CHANGE 1
TO
KWM-380/HF-380 SERVICE BULLETIN NO 8

KWM-380 TRANSCEIVER (622-5093-001)
HF-380 TRANSCEIVER (622-3580-001)
RECEIVER/EXCITER ASSEMBLY A3 (638-6908-002)

SERVICE BULLETIN NO 8

PRODUCT IMPROVEMENT

P/O Receiver/Exciter A3, Component Installation Diagram
Figure 1 (Sheet 1 of 2)

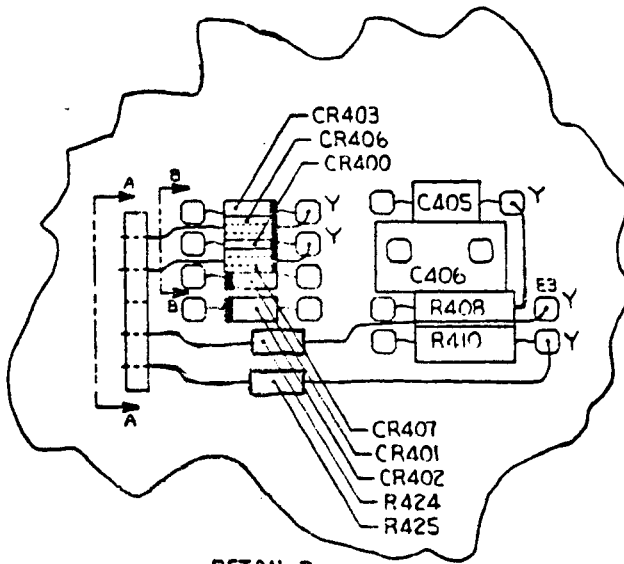
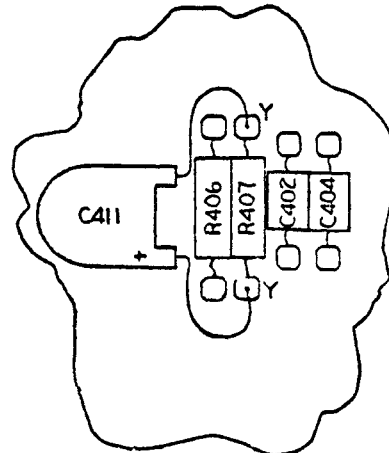
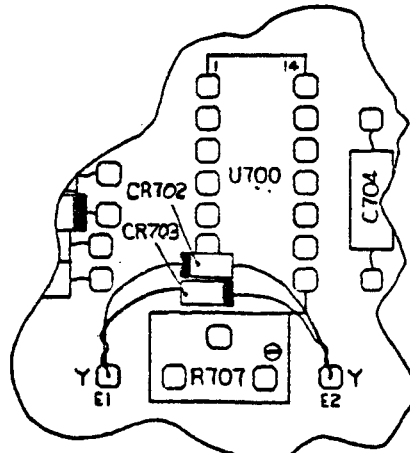
- C. Install contacts, 372-2656-130 (square pins) at E1 and E2 (holes in board) and solder. Refer to figure 1, detail A.
- D. Install 1N4454 diode CR702 (353-3644-010) with cathode to E1 as shown in figure 1, detail A.
- E. Install 1N4454 diode CR703 (353-3644-010) with cathode to E2 as shown in figure 1, detail A.

- F. Remove both leads of resistor R407 and install a contact (372-2656-130) in each hole.
- G. Connect the R407 leads to the new contacts.
- H. Install 100- μ F capacitor C411 (184-9102-100) to the new contacts with the positive side to the bottom of R407 as shown in figure 1, detail C.

- K. Position 1N4454 diode CR406 (353-3644-010) as shown in figure 1, detail B, section BB. Connect the cathode end to the contact installed in step I.

- L. Position 1N4454 diode CR407 (353-3644-010) as shown in figure 1, detail B, section BB. Connect the cathode end to the contact installed in step J.

- S. Cut a terminal strip (797-3615-001) into one block of five holes.
- T. Position the terminal block as shown in figure 1, detail B, and secure it to the circuit card using commercially available epoxy or bonding adhesive.
